## STAFF REPORT

### NEW BEDFORD HISTORICAL COMMISSION MEETING

#### CASE # 2019.15: CERTIFICATE OF APPROPRIATENESS

15 Hamilton Street (Map 53 Lot 177)

**PROPOSED FIBERGLASS GUTTER PROFILE TO MATCH EXISTING**

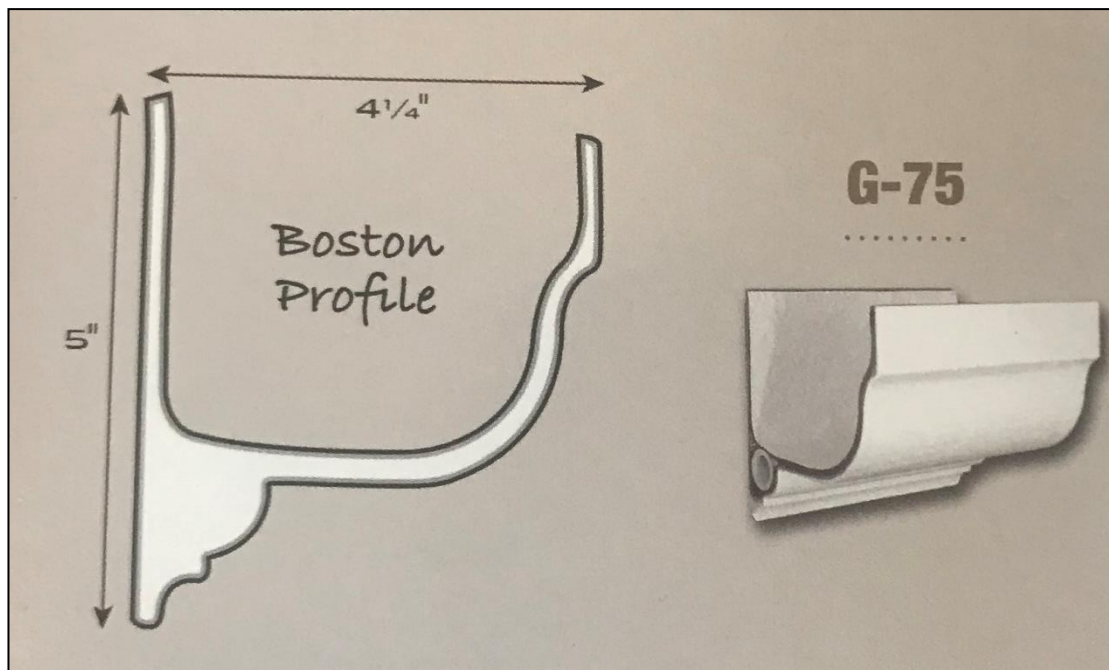
**PROPOSAL:** The applicant is proposing to replace all the existing wood gutters which are beginning to exhibit signs of rot with fiberglass gutters which will match the existing gutter profile and will be painted to match the existing paint color.

**STAFF RECOMMENDATION:** Historical Commissions throughout the Commonwealth are beginning to recognize that historic wood gutters are not sustainable, as they are difficult to maintain, do not shed water adequately, and often result in cornice and fascia issues. Commissions are allowing fiberglass gutters to replace wood gutters, as manufacturers can match common wood gutter profiles, the fiberglass can be painted, and they shed up to 30% more water than shallow wood gutters. Staff recommends the approval and the issuance Certificate of Appropriateness for the fiberglass gutters.
